P-021

Police Modifier Bulletin

Date: 9 September, 2014

Utility Police Interceptor with Side Marker LED – Sideview Mirror LED Lights Option (63B)

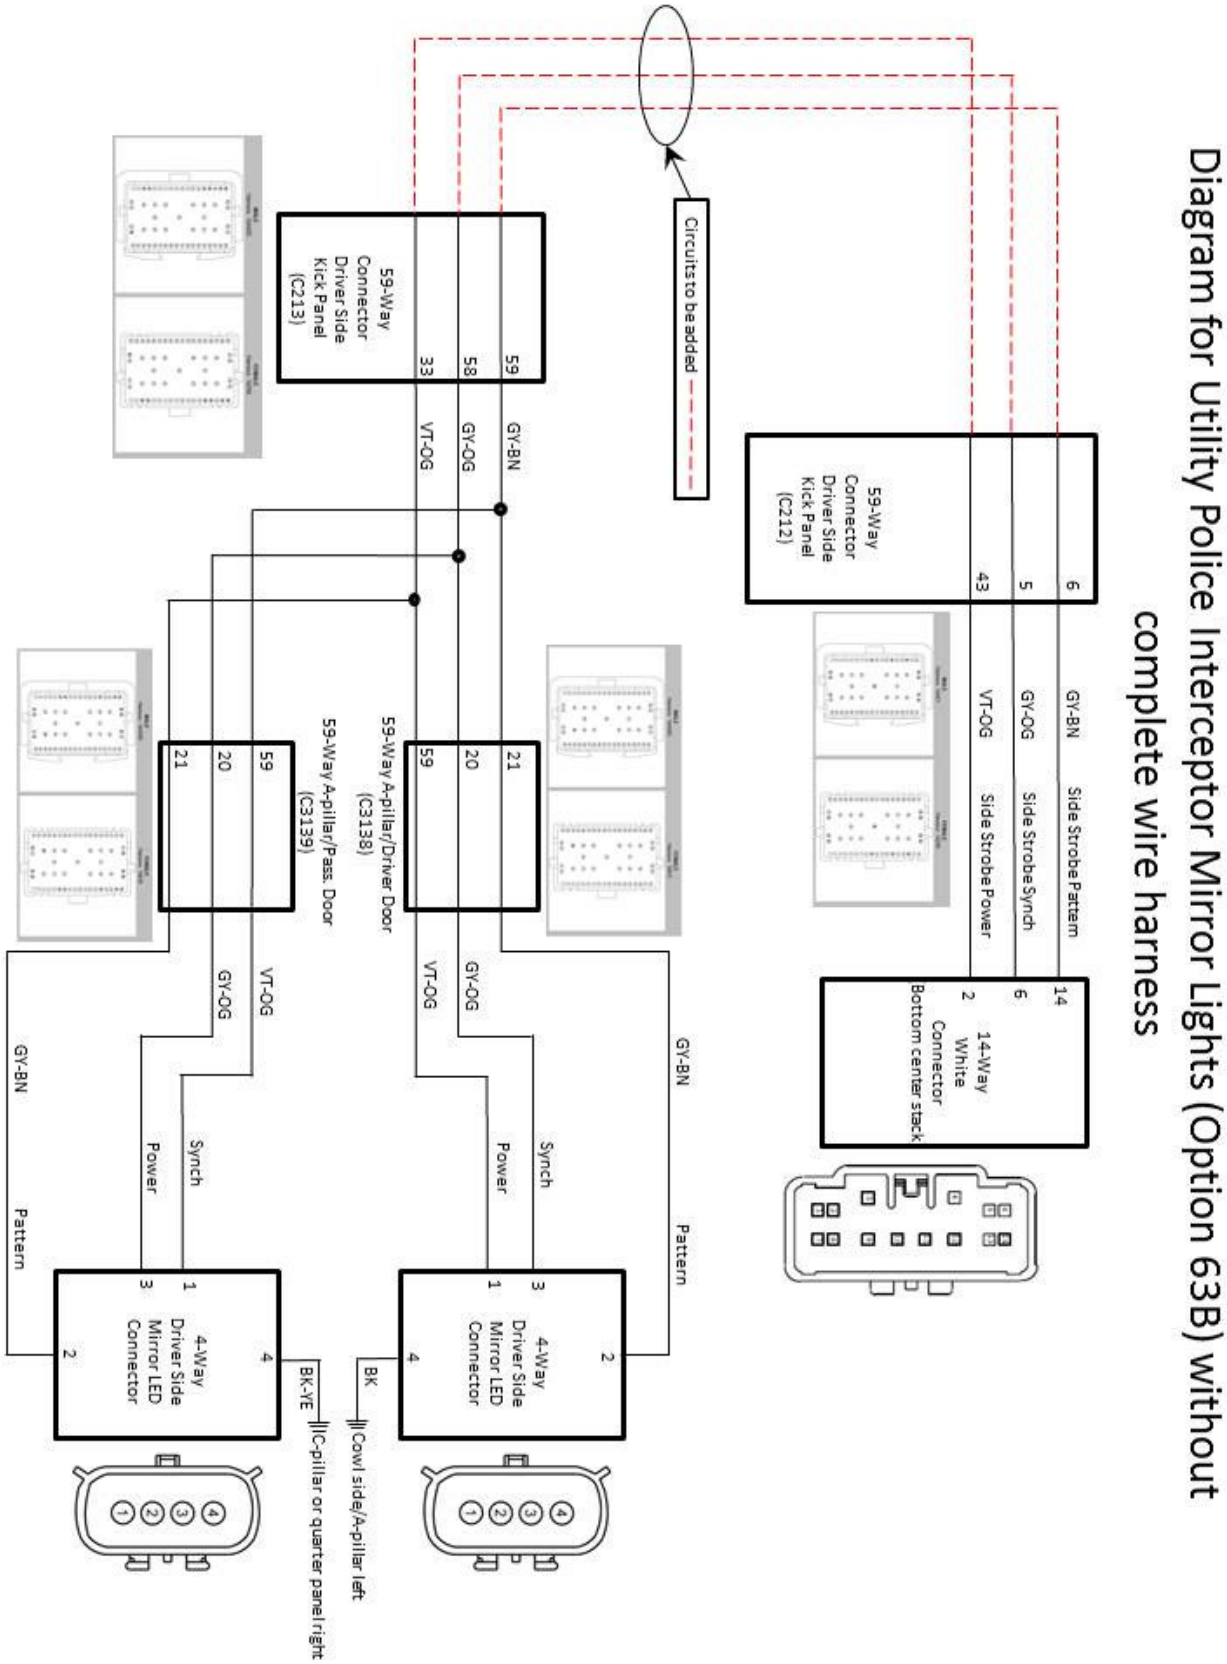
Purpose
Some 2014MY and 2015MY Utility Police Interceptors may have been ordered without a wire harness option that would provide the circuits to power the Mirror LED lights.

Vehicles with Option 63B that do not have the wire harness to complete the circuit for Mirror LED lights see diagram on page 2 of 2 in this document.

This bulletin provides wiring suggestion to complete circuits for the mirror LED light option on Utility Police Interceptors ordered without the wiring to complete the circuits to operate the Mirror LED lights.

Vehicle Orders Placed with Mirror LED Light Option
Effective 8/27/14, orders placed with option: **Side Marker LED – Sideview Mirrors (63B)** now require the Pre-Wiring for Grille, Siren and Speaker (60A) if the following options were not ordered:
